Customer Service Bulletin SD800005

Cable Issues in SLF20050/C3 Antenna Couplers

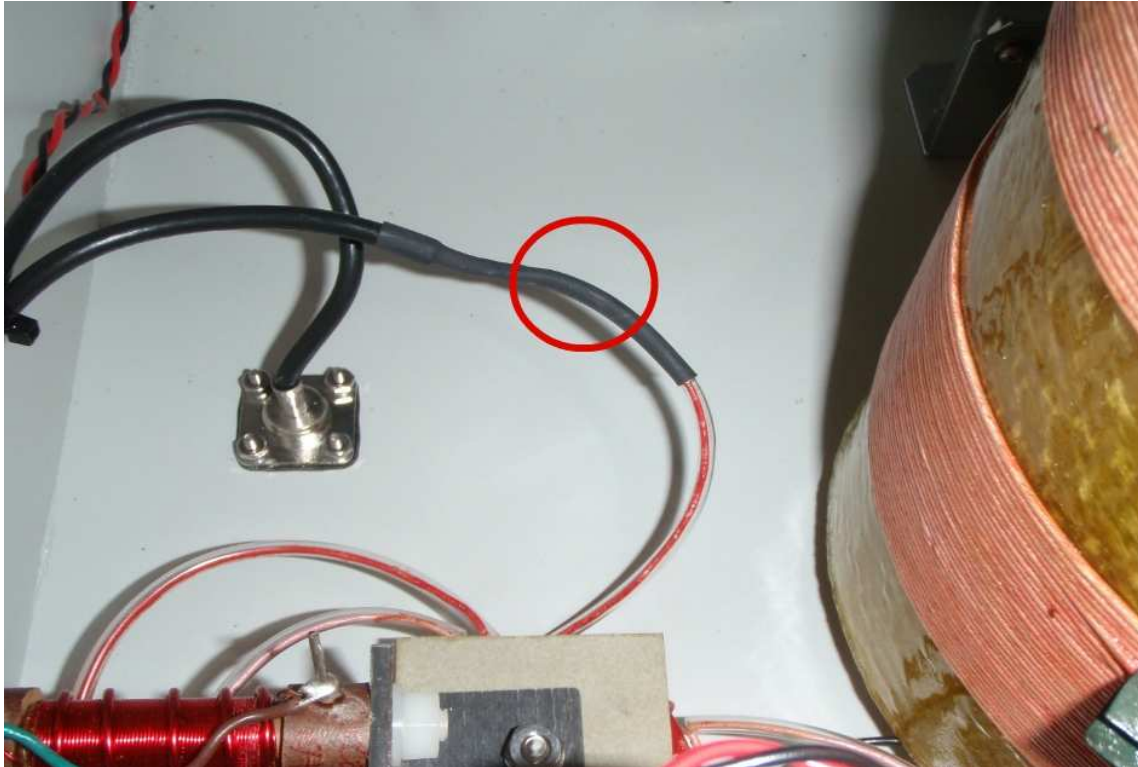
Remove heat shrink from this area

REMOVE SHIELD

WIRE 12:
STRIP OUTER JACKET BACK 2" AND
REMOVE SHIELD FROM STRIPPED SECTION.
SOLDER CENTER TO T1 PRIMARY FINISH
AND INSULATE WITH HEATSHRINK.

1. Please remove the heat shrink tubing from Wire 12, and verify the braided ground shield is stripped back, as shown below, to prevent possible contact of the coaxial cable's braided shield and center conductor. Re-secure connection with electrical tape or heatshrink wrap.
2. Inspect the area inside the coupler enclosure and verify none of the cables are near the tuning coil. Tie wrap wires to a secure location as necessary.

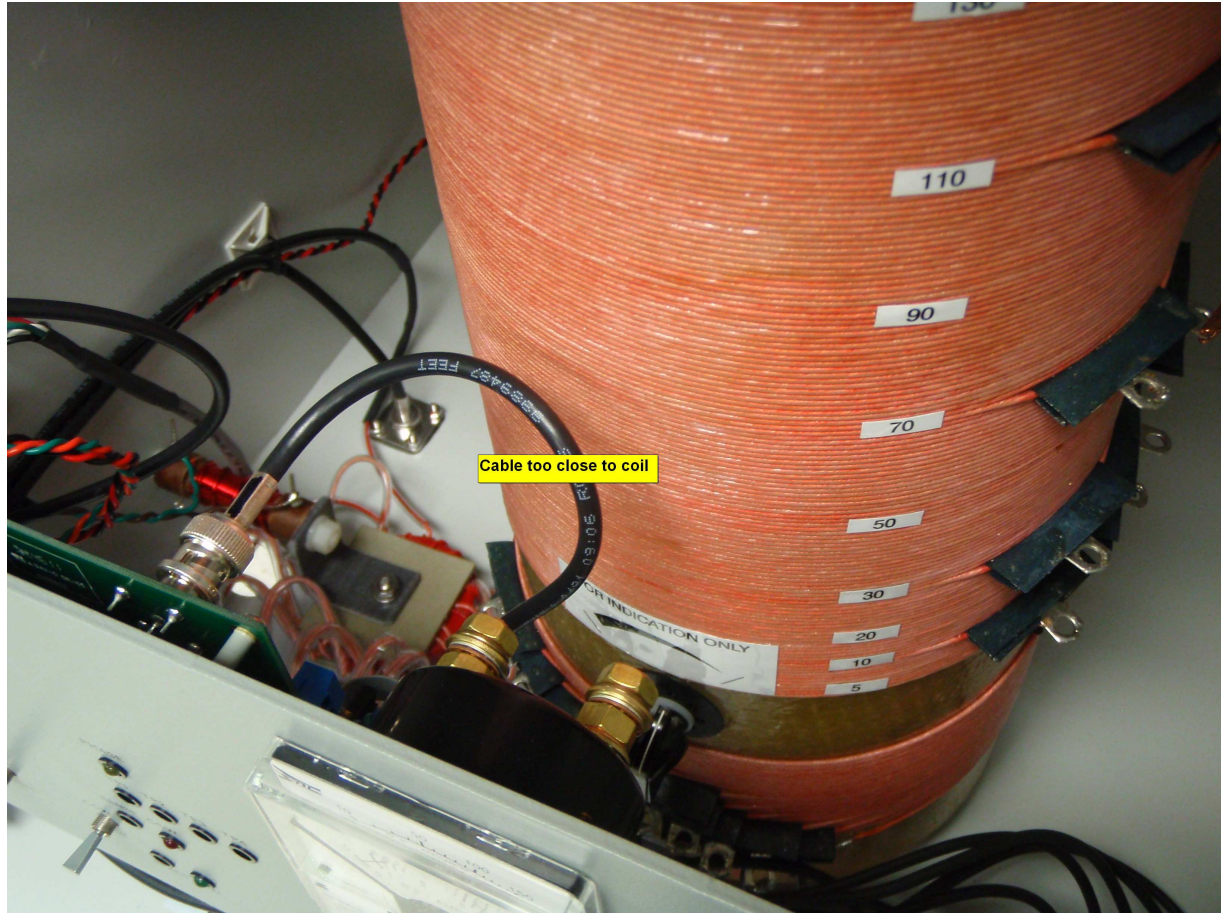
Verify shield is stripped fully per diagram.

Cable too close to tuning coil.

Cable pulled back and secured.
